CMB Meeting Minutes #178

SUBJECT: Configuration Management Board Meeting # 178 – Rev. No. 0

Project No. M544.1, Contract No. CS-149
Program/Construction Management
Configuration Management Board (CMB) Meeting No. 178
July 16, 2014
3:00pm – 5:00pm
Central Subway Project Office
821 Howard St. 2nd Floor
Main Conference Room

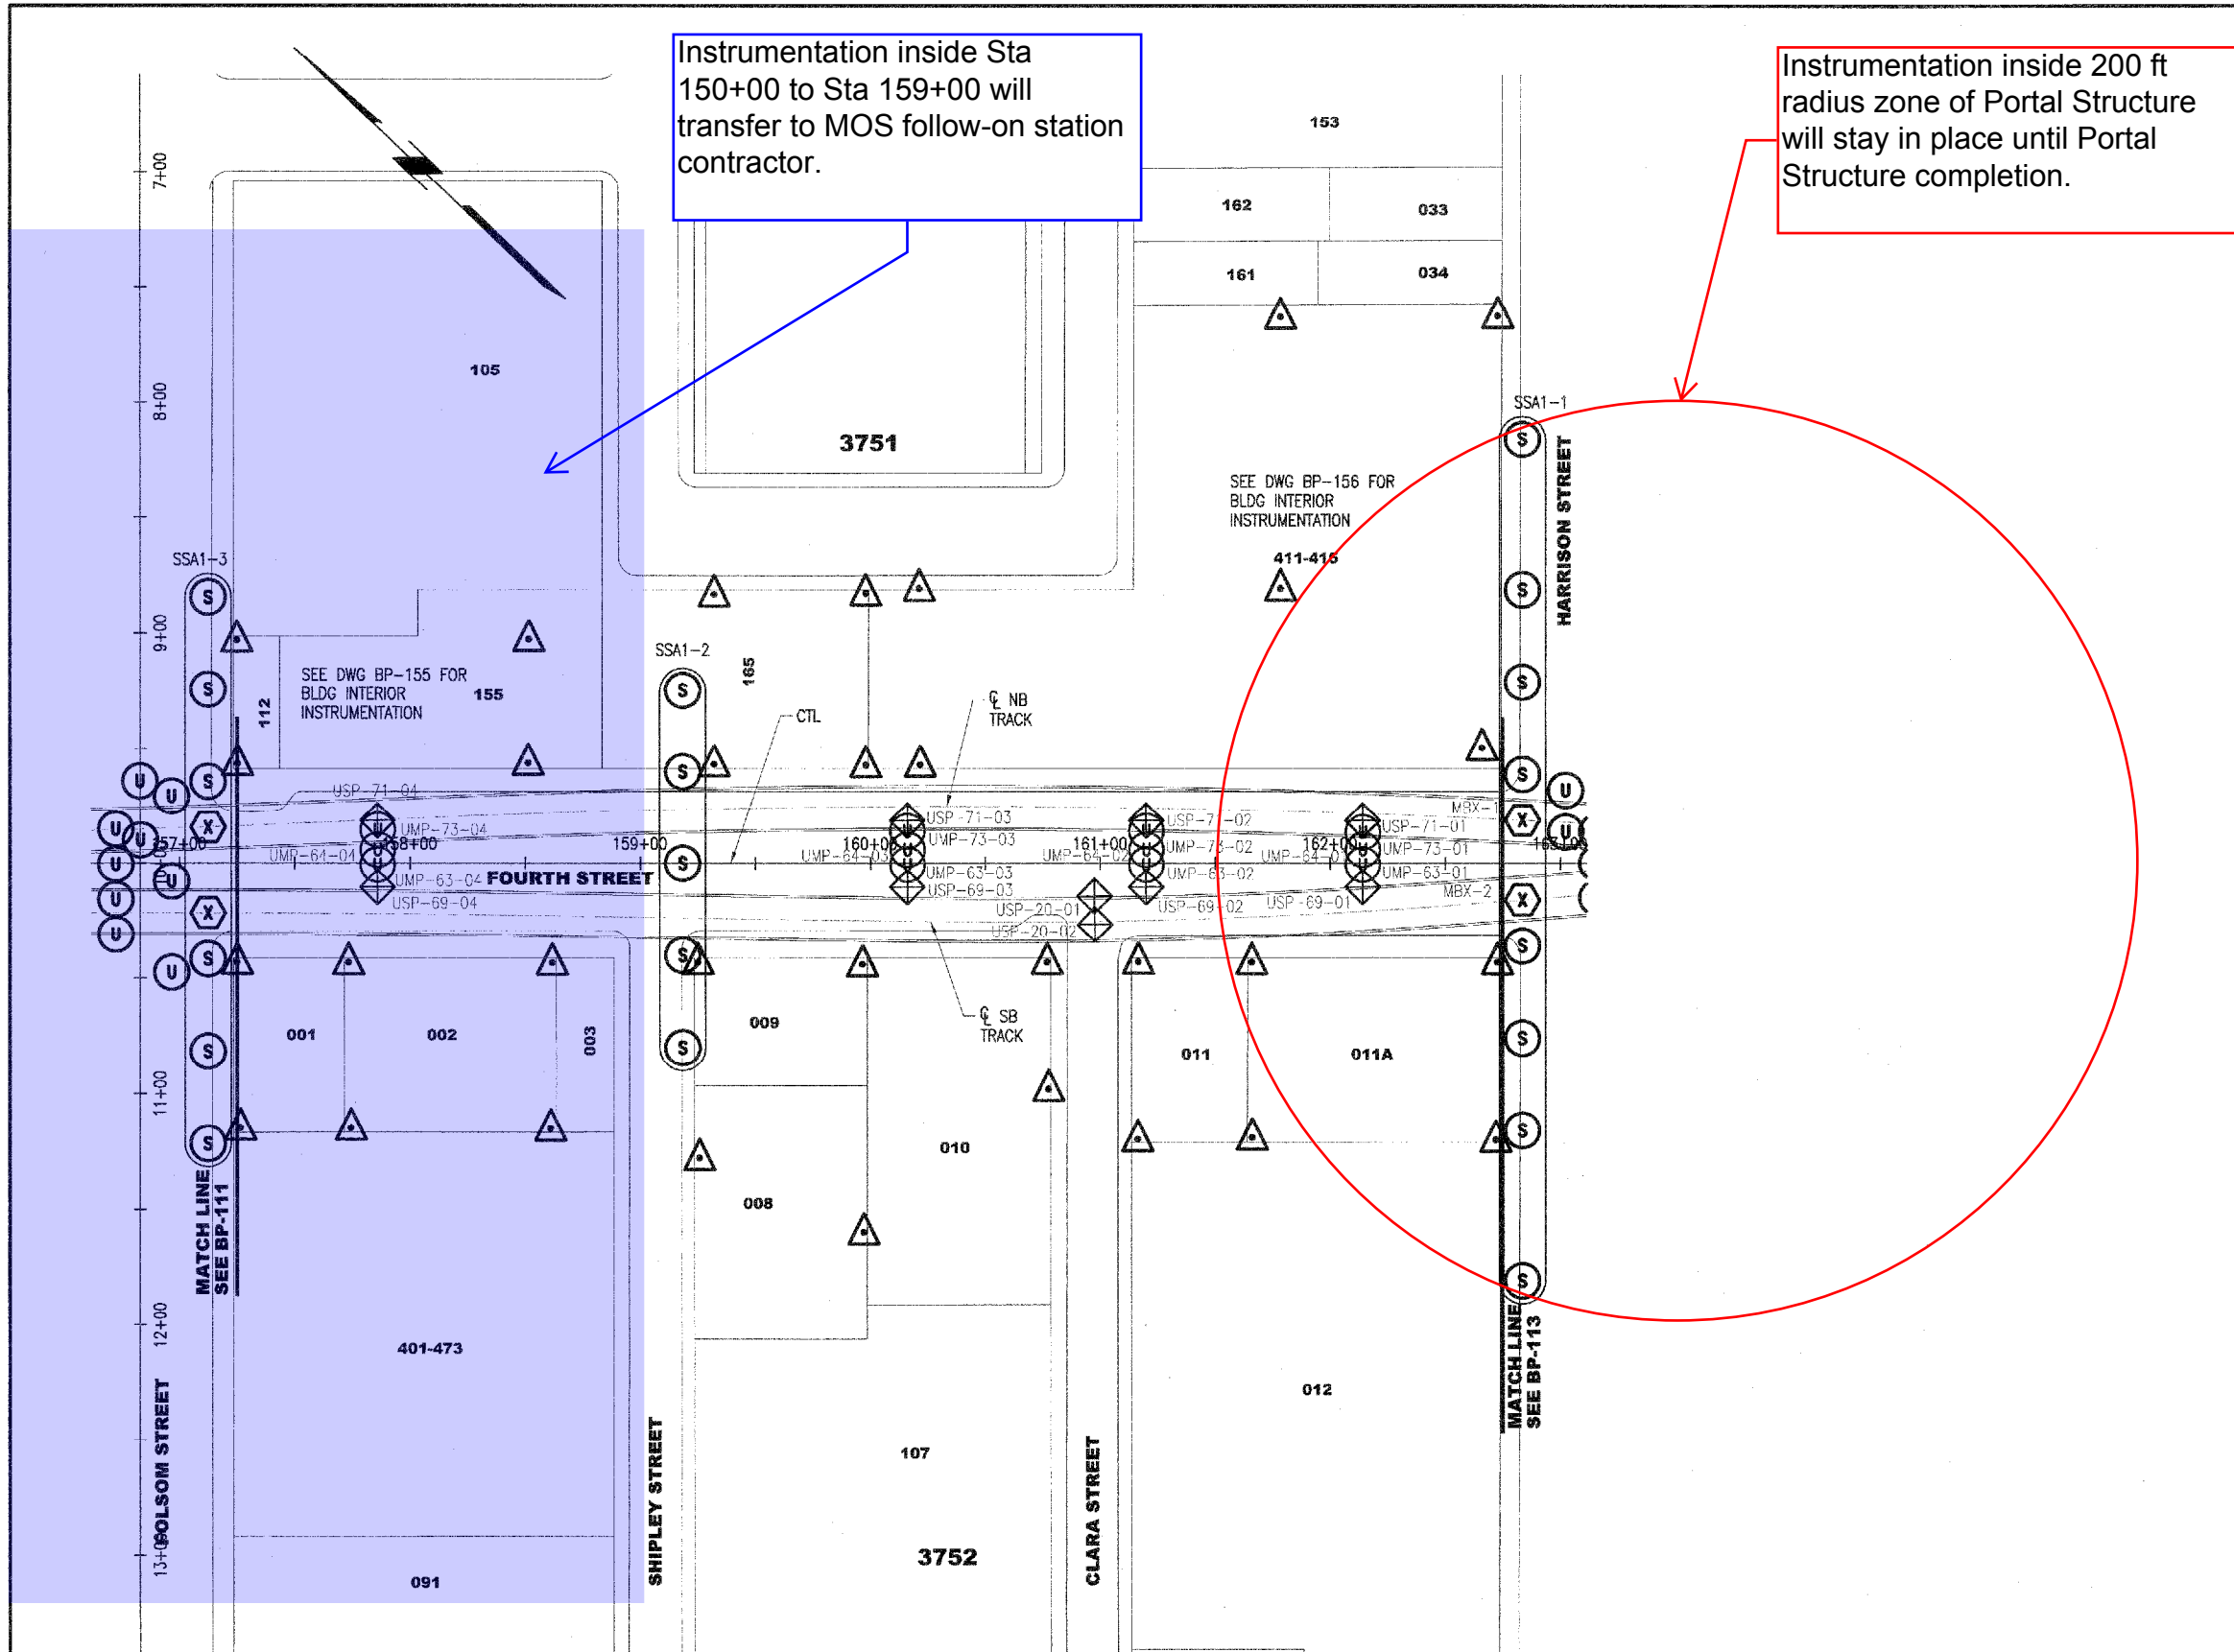
The attached marked-up contract drawing (BP-112) shows a red circle representing a zone of influence area extending 200 feet from the north edge of the future Portal Structure which will continue to be monitored until completion of the Portal Structure work.

Instruments shown on attached contract drawing BP-112 not included in the red circle (Portal Structure area) or the blue area (MOS turnover area) are requested to be abandoned and area restored per the Contract documents.

Instrumentation inside Sta 150+00 to Sta 159+00 will transfer to MOS follow-on station contractor.
